ST10F276E, ST10F275E, ST10F273E Errata sheet

16-bit MCUs with
512/768/832 KByte Flash and 36/36/68 KByte RAM memories

This errata sheet describes all the functional and electrical problems known in the Cxx silicon versions of the ST10F276E, ST10F275E and ST10F273E.

Figure 1. Calibration mechanism (during bit 9 comparison phase)

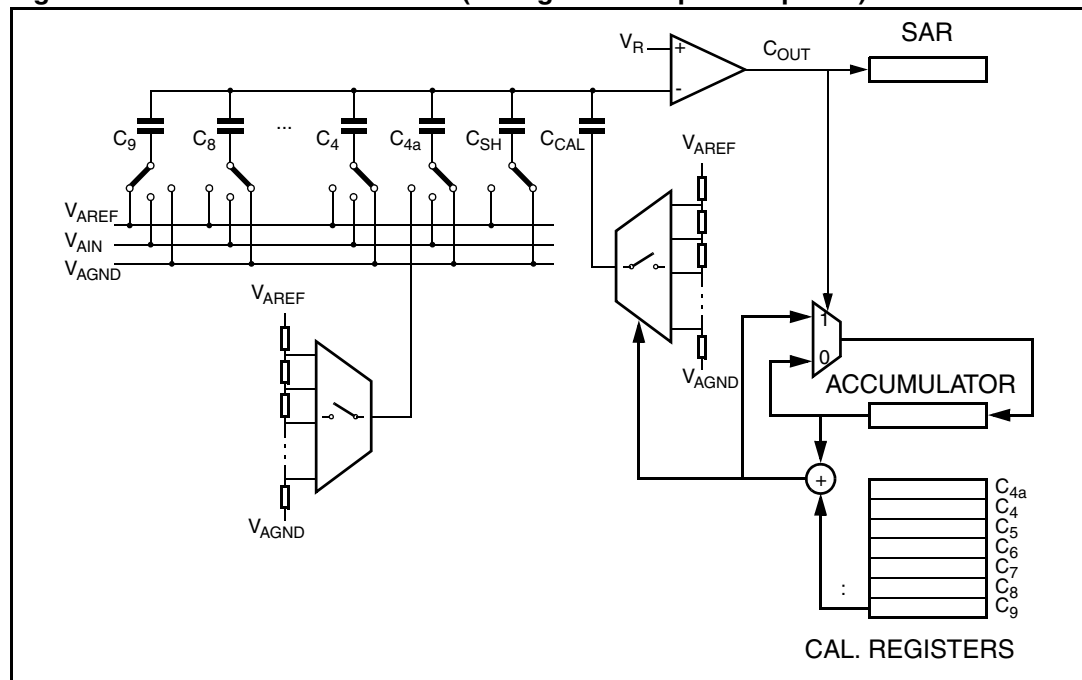
On specific analog input values an accuracy degradation of several LSBs may be seen on the digital output value of the implemented ADC. In particular this occurs if the input voltage matches the internal comparator thresholds, which is when a roll over from the least significant bits (that is, 0x1Fh -> 0x20h or viceversa) occurs.

The maximum deviation in accuracy is ± 250 mV over the entire conversion range.

The failure is linked to the implemented “self calibrating circuitry” which is summarized in the [Figure 1](#).

The maximum correction applied by the calibration is 250 mV.

When the analog input voltage is close to one of the thresholds of the comparator (by less than 1 mV), then the amplifier sees a differential voltage very close to zero. As a result, the output of the comparator is fluctuating between the values “0” or “1”. Because of the parallel use of the comparator output and of the fluctuating value, different values may be latched in the SAR (successive approximation register) and the calibration section. As a result a bad calibration mechanism is applied to the successive bit.

It is not possible to define a workaround generic for all applications.

Figure 2. ADC injection theoretical operation

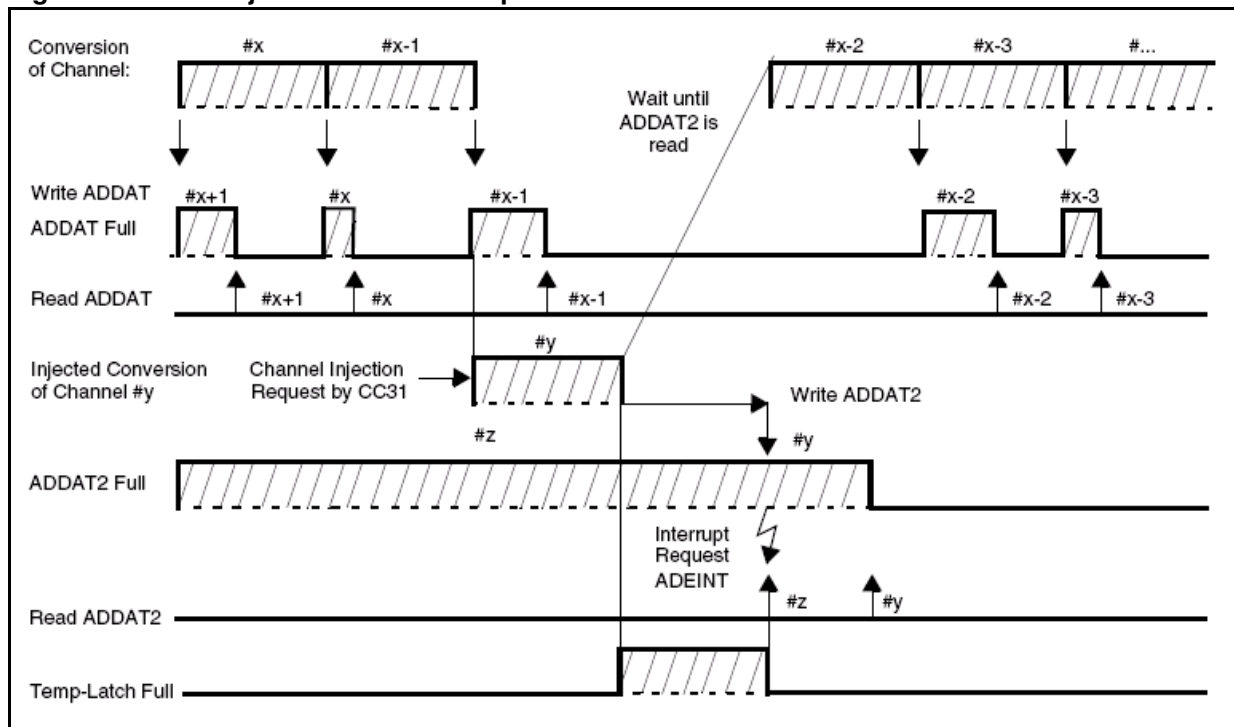
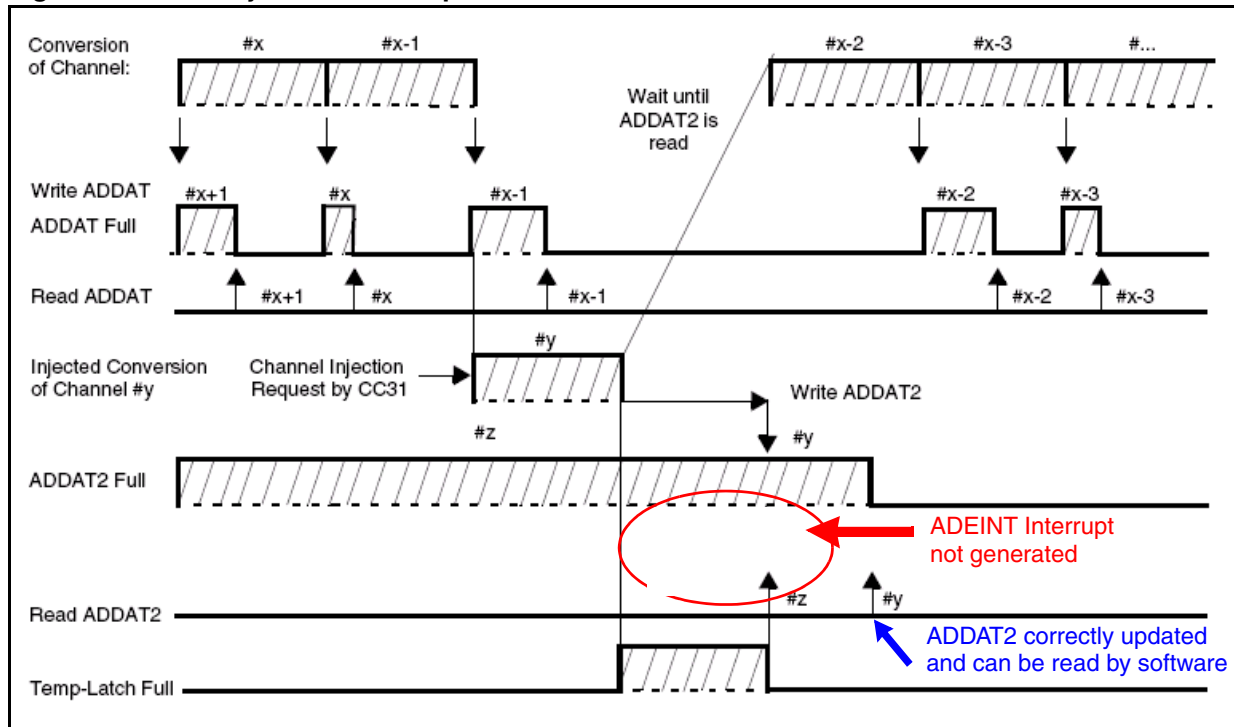
Whenever a new Injection request is issued before the ADDAT2 register has been read by the CPU (that is the result of the previous injection request was not read), the ADC is stalled and no further conversions are performed.

For a correct functionality as soon as ADDAT2 register is read then the last converted value should be moved from temporary register to ADDAT2 and the ADEINT interrupt request should be issued. This would allow the CPU to read the last converted value (see [Figure 2](#)).

In the real situation as soon as ADDAT2 register is read then the last converted value is correctly moved from temporary register to ADDAT2 but **the ADEINT interrupt request is not received by the interrupt controller** (see [Figure 3](#)). As a consequence the CPU/PEC never knows that a new converted value is ready to be read in ADDAT2 register and therefore at the following injection request the ADC fills the temporary register again (without generating any ADEINT interrupt request) and then stalls the ADC for any further conversion. The ADC stays in the “wait-for-read ADDAT2 register” condition forever.

1. Read the ADDAT2 register twice at the end of every injected conversion (also prevents stall condition to occur)
2. Disable then re-enable the wait-for-read mode

Figure 4. ST10 in slave mode

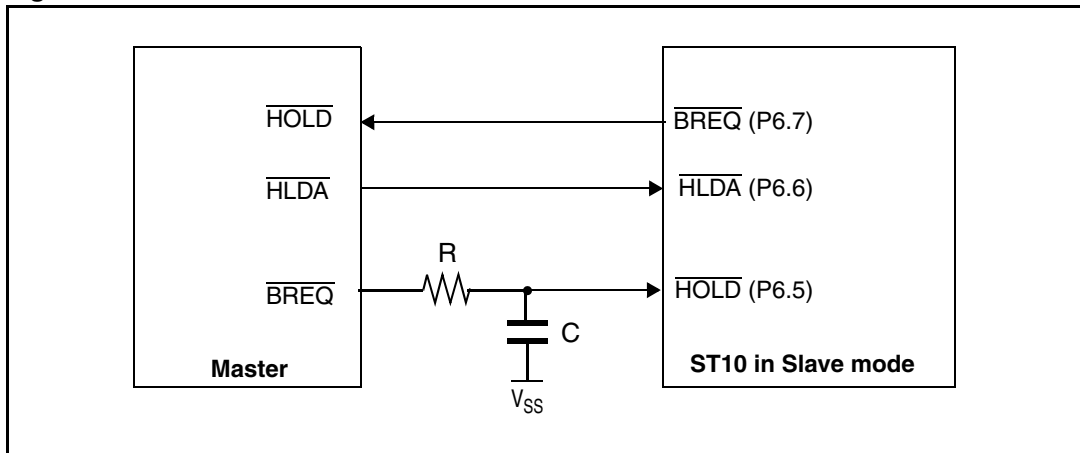
When using external bus arbitration via HOLD-function with the ST10F276 configured as a slave, sporadic bus errors may occurs.

After the slave has been granted the bus, the slave deactivates BREQ sporadically for a short time, even though the bus access of the slave has not been completed. The master then starts its own bus access, leading to a bus conflict between master and slave.

In order not to produce any spurious BREQ pulse during a slave external bus arbitration phase, it is necessary to guarantee that the distance between the HOLDA assertion (bus acknowledge from master device) and the following HOLD falling edge (bus request from master) is greater than three clock cycles.

This can be implemented by delaying the HOLD signal with a RC circuit as shown in [Figure 4](#).
